AMENDMENTS TO THE DRAWINGS

Jong-Joo LEE and Dong-Ho LEE
 MULTI-CHIP BALL GRID GRID ARRAY PACKAGE
 Attorney Docket No. 9903-080/Application No. 10/828,792

Annotated Sheet Showing Changes

FIG. 2

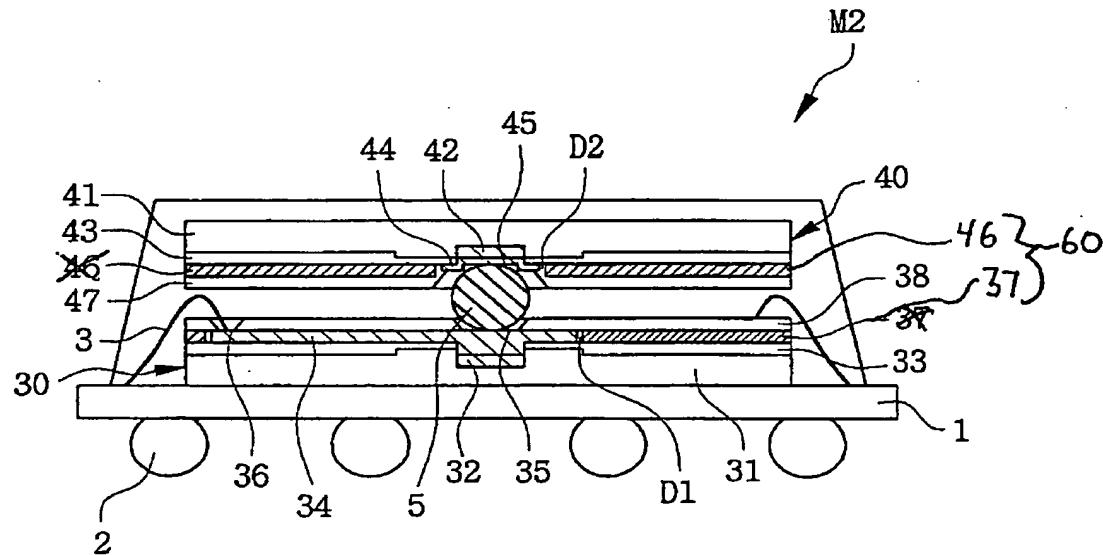
FIG. 2 is amended to include reference number 60 identifying the capacitor provided by the first and second electrode plates 37 and 46. An annotated sheet showing changes and replacement sheet are included in the Appendix following page 11 of this paper.

In a telephonic interview between the Applicant and the Examiner, conducted on August 31, 2005, the Examiner clarified that rejection was due to the capacitor not being specifically identified within any of the drawings. In response to the Applicant's question on how to overcome this rejection, the Examiner agreed that a separate reference number could be added to FIG. 2 to identify the capacitor formed by electrodes 37 and 46. FIG. 2 is amended to identify the capacitor as reference number 60 and a replacement sheet with the amended figure is included and can be found in the Appendix following page 11.
